ADDENDUM TO THE SECTION 42A REPORT

1.0 Hastings Character Residential Zone Recommendations

7.2.5G SPECIAL BUILDING SETBACKS

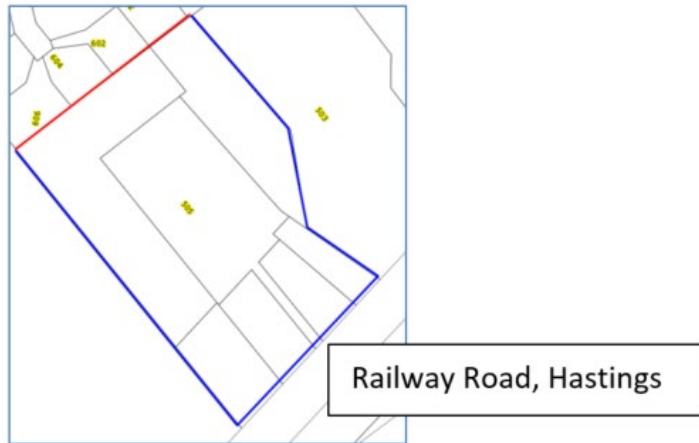
9.0 Consequential Amendment - General Residential Zone Rules and General Performance Standards – Rule GR12 & Standard 7.2.5G Special Buildings Setbacks – 505 & 507 Railway Road

9.1 As a result of the recommendations in relation to the spatial extent of the Medium Density Residential Zone (MDRZ) the property at 505 and 507 Railway Road (the Angus Inn site) is no longer recommended to be included in the MDRZ. Therefore, it is recommended to retain its current General Residential Zoning.

9.2 The specific provisions associated with this site were to be relocated to the MDRZ as per the notified version of PC5, however, however, given the change outlined above, they now need to be reinstated in the Hastings General Residential Zone provisions.

9.2 The provisions affected are Rule GR12 and standard 7.2.5G as outlined below and are shown as such in the tracked changes version of section 7.2 Hastings Residential Environment:

a. 505 and 507 Railway Road South, Hastings

No building located within 50 metres of the rear boundary (see diagram below the red line denotes the rear boundary of the site) at 505 and 507 Railway Road South, Hastings, being Lots 1-4 DP 10795, Lot 1 DP 8625, Lot 1DP 19254 and Lot 2 DP 25702 shall be used as premises for the sale of liquor.
